NON-COMPLIANCE REPORT # 31787-54

PART NAME: ENCODER SENSOR MOUNT
PF/SA NO.: PF-391-524-98
WORK ORDER NO.: 31787-54
VENDOR: BT LASER

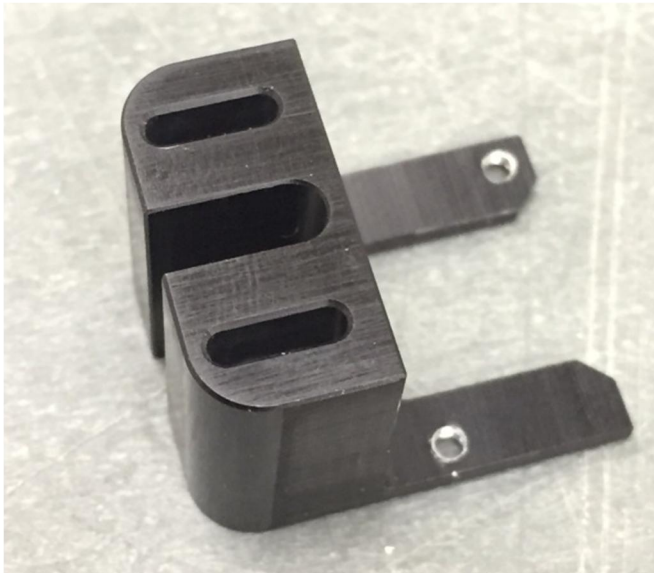
1. 2 MASK THREADS AND .073 WIDE SLOTS PRIOR TO ANODIZING , .073 wide slots we not masked, see photo below.
 - a. .073 +.001/-0.000 are within tolerance even with anodizing (.0735)
